Item Name: Heli-Access-Step RH

# DART SERVICE INSTRUCTION

TO AMEND INSTALLATION INSTRUCTIONS IIN-D119-675 REV. B AND  
INSTRUCTIONS FOR CONTINUED AIRWORTHINESS ICA-D119-675 REV. 2  
REF. FAA STC SR00948SE & EASA STC EASA.IM.R.S.01458

A	NEW ISSUE	AJS	13.04.04
REV.	DESCRIPTION	BY	DATE
DESIGN	AJS	<b>DART AEROSPACE USA, INC</b> KENT, WA	
DRAWN	AJS		
CHECKED	<i>[Signature]</i>	DRAWING NO.	REV. A
MFG. APPR.	N/A	DSI 9647	SHEET 1 OF 6
APPROVED	<i>[Signature]</i>	TITLE	SCALE
DE APPR.	<i>[Signature]</i>	CLAMP REPLACEMENT	NTS
DATE	13.04.04	COPYRIGHT © 2013 BY DART AEROSPACE USA, INC <small>THIS DOCUMENT IS PRIVATE AND CONFIDENTIAL AND IS SUPPLIED ON THE EXPRESS CONDITION THAT IT IS NOT TO BE USED FOR ANY PURPOSE OR COPIED OR COMMUNICATED TO ANY OTHER PERSON WITHOUT WRITTEN PERMISSION FROM DART AEROSPACE USA, INC.</small>

FIGURE 1 - D119-675-011/-012 HELI-ACCESS-STEP™

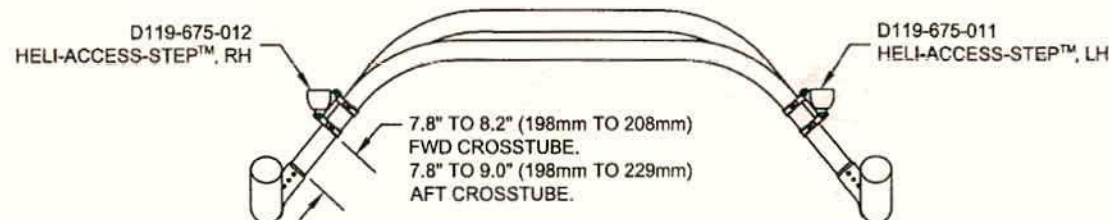
**NOTE:** It is acceptable to leave the short steps on the landing gear provided they do not interfere with the installation of the Dart step in accordance with the dimensions shown in View A-A of Figure 1.

3.5 Find the appropriate step height by locating the step/clamp as shown in View A-A. Locate the forward D3041-1/-3 Clamp 7.8"- 10.4" above the crosstube cuff. Locate the aft D3041-1 Clamp 7.8"-11.6" above the crosstube cuff. The distances given are from the crosstube cuff to the bottom-most clamp.

**IS:**  
**SECTION B-B**  
 FWD CROSSTUBE,  
 VIEW ROTATED

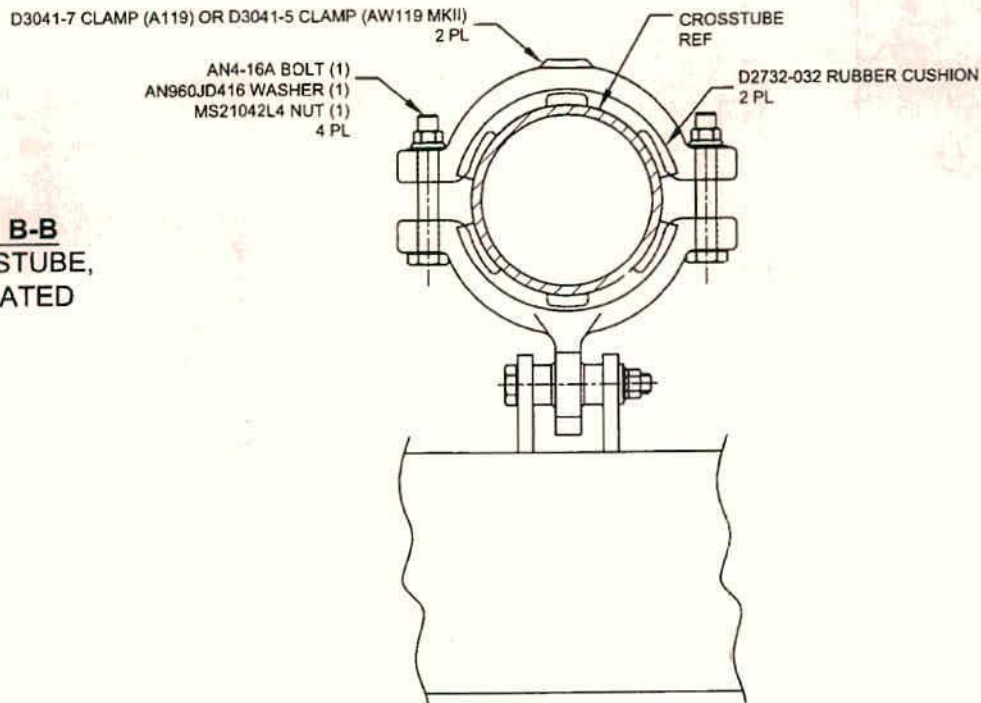
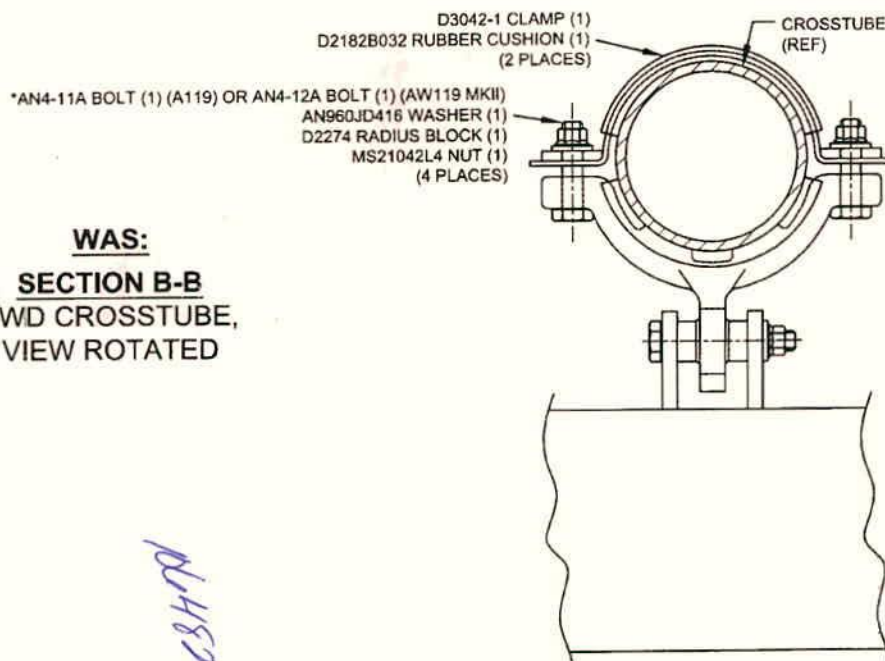
The purpose of this Service Instruction is to improve installation of D119-675-011/-012 *Heli-Access-Steps*. This improvement consists of replacing the inboard D3042-1 Clamps and D2182B032 Rubber Cushions with D3041-5/-7 Clamps and D2732-032 Rubber Cushions.

- 2.1 The DSI 9647-011 Clamp Replacement Kit can be procured from Dart. One kit upgrades one step.
- 2.2 Remove and discard the D3042-1 Clamps, D2182B032 Rubber Cushions and hardware. Replace with the D3041-5/-7 Clamps, D2732-032 Rubber Cushions and hardware as shown in Section B-B and C-C of this Service Instruction.
- 2.3 Tighten clamp bolts. Do not exceed torque of 60 in-lb (6.8 nm) on the nuts.  
**CAUTION:** Over-torquing the nuts could lead to structural damage of the clamps.
- 2.4 Amend weight and balance per section 4.0 of this Service Instruction.

3.4 Install the D2732-032 Rubber Cushions under the D3041-1/-3/-5/-7 Clamps (see Sections B-B and C-C (of this DSI)).

3.6 Tighten the clamp bolts. Do not exceed torque of 60 in-lb (6.8 Nm) on the nuts.

**IS:**  
**SECTION C-C**  
**AFT CROSSTUBE,**  
**VIEW ROTATED**

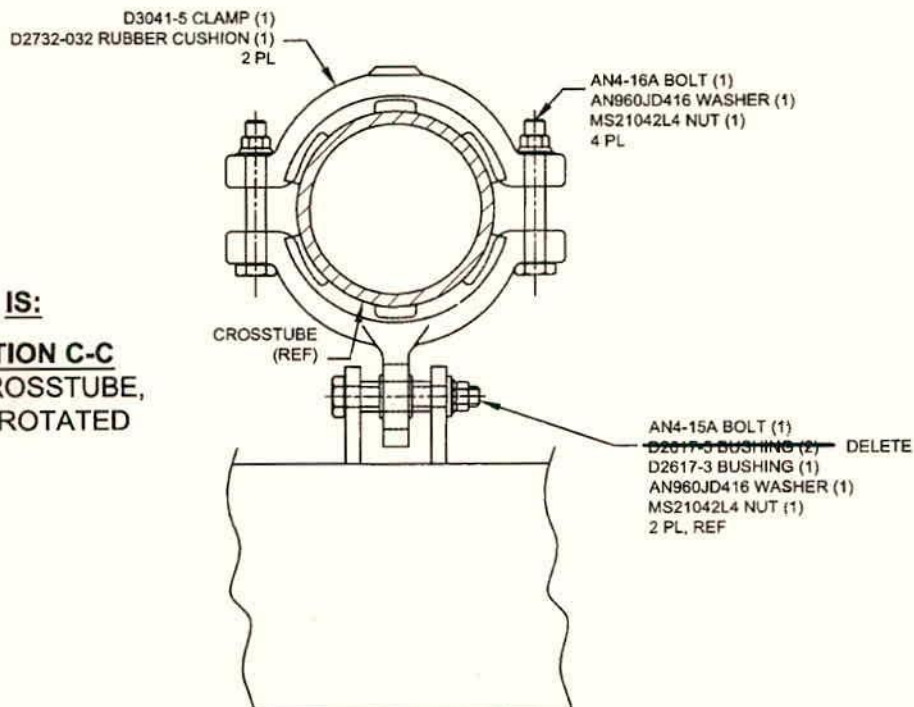
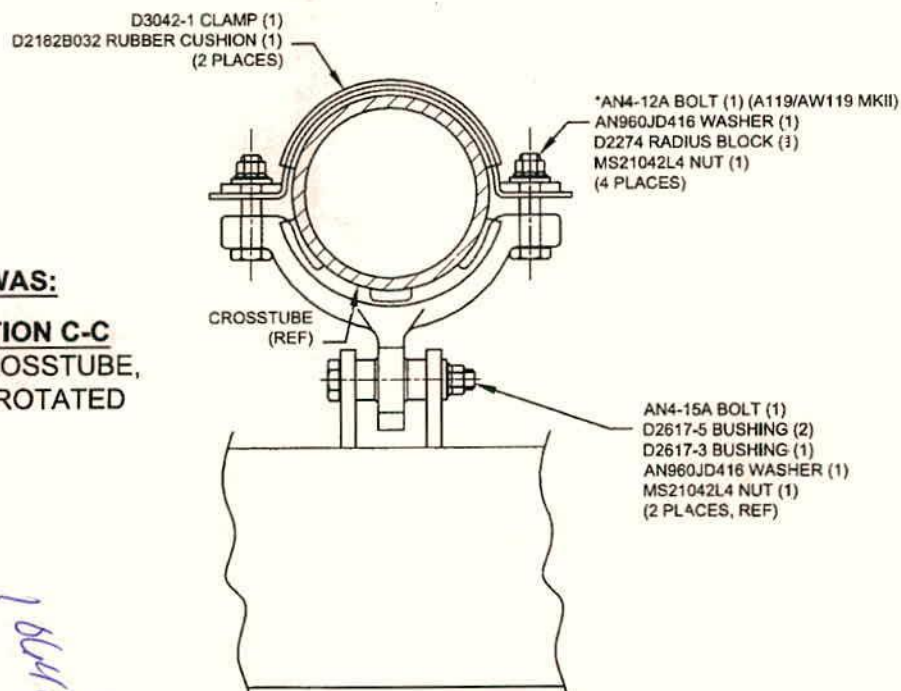
For existing installations (D119-675-011/-012 *Heli-Access-Steps* @ Change 004 or earlier), this service instruction also recommends removal of the D2617-5 Bushings at the aft crosstube position to prevent the bearings in the D3041-1/-3 clamps from being pushed out and makes it permissible for operators to raise the step an additional 2.00 inches (51mm) to provide clearance for the ground handling wheels. Refer to section 2.0 of this Service Instruction.
